PIC16(L)F1934/1936/1937 Family Silicon Errata and Data Sheet Clarification

The PIC16(L)F1934/1936/1937 family devices that you have received conform functionally to the current Device Data Sheet (DS41364E), except for the anomalies described in this document.

Note: This document summarizes all silicon errata issues from all revisions of silicon, previous as well as current. Only the issues indicated in the last column of [Table 2](#) apply to the current silicon revision (A9).

FIGURE 1: INSTRUCTION CYCLE DELAY CALCULATION EXAMPLE

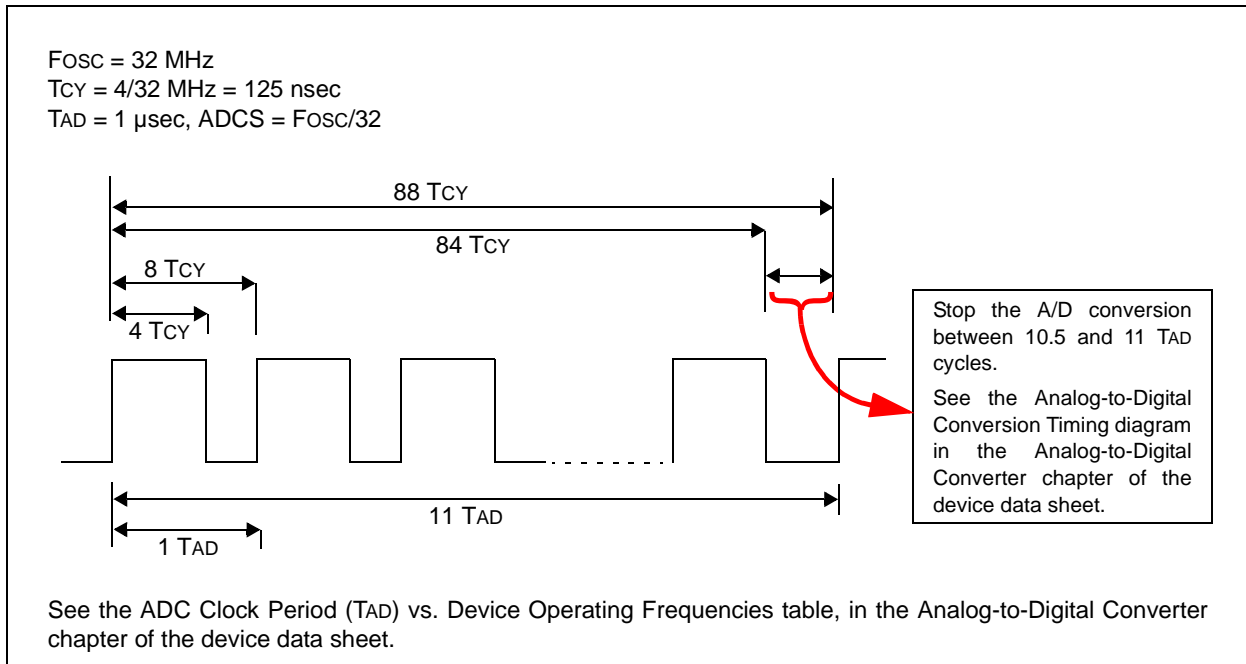
An ADC conversion may not complete under these conditions:

1. When FOSC is greater than 8 MHz and it is the clock source used for the ADC converter.
2. The ADC is operating from its dedicated internal FRC oscillator and the device is not in Sleep mode (any FOSC frequency).

When this occurs, the ADC Interrupt Flag (ADIF) does not get set, the GO/DONE bit does not get cleared, and the conversion result does not get loaded into the ADRESH and ADRESL result registers.

Method 3: This method is provided if the application cannot use Sleep mode and requires continuous operation at frequencies above 8 MHz. This method requires early termination of an ADC conversion. Provide a fixed time delay in software to stop the A-to-D conversion manually, after all 10 bits are converted, but before the conversion would complete automatically. The conversion is stopped by clearing the GO/DONE bit in software. The GO/DONE bit must be cleared during the last 1/2 TAD cycle, before the conversion would have completed automatically. Refer to [Figure 1](#) for details.

In [Figure 1](#), 88 instruction cycles (TCY) will be required to complete the full conversion. Each TAD cycle consists of 8 TCY periods. A fixed delay is

provided to stop the A/D conversion after 86 instruction cycles and terminate the conversion at the correct time as shown in the figure above.

Note: The exact delay time will depend on the TAD divisor (ADCS) selection. The Tcy counts shown in the timing diagram above apply to this example only. Refer to [Table 3](#) for the required delay counts for other configurations.
